Rezoning Transportation Analysis

Petition Number: 2018-083

General Location Identifier: 175814115

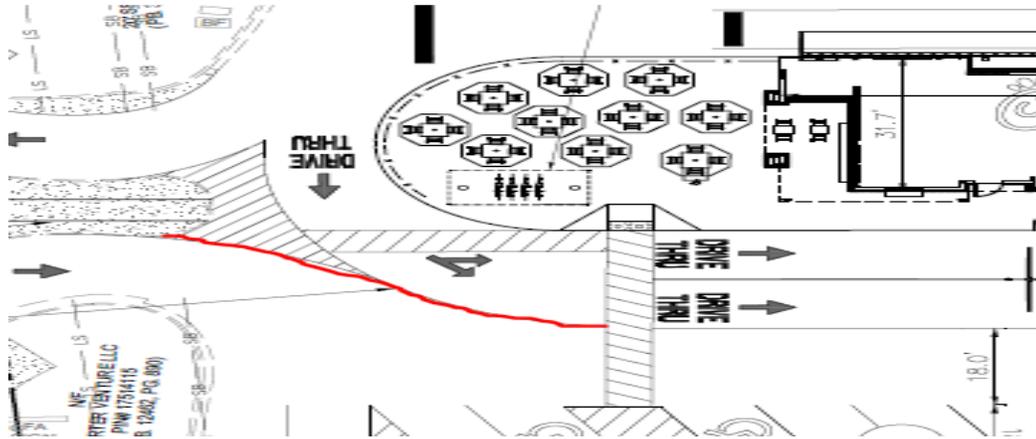
1. ~~Traffic Study~~ A Traffic Impact Study/Transportation Technical Memorandum is not necessary for the complete review of this petition.
2. The petitioner should revise the site plan and conditional note(s) to show concrete median instead of "removable magnetic delineators" to prohibit vehicles from going straight into drive-thru line (see attached exhibit).

4. NEW COMMENT: Petitioner should update site plan and conditional notes is to create a smaller radius for the right-in access to the site
5. The petitioner should revise the site plan and conditional note(s) to construct an 8' planting strip and a 6' sidewalk.
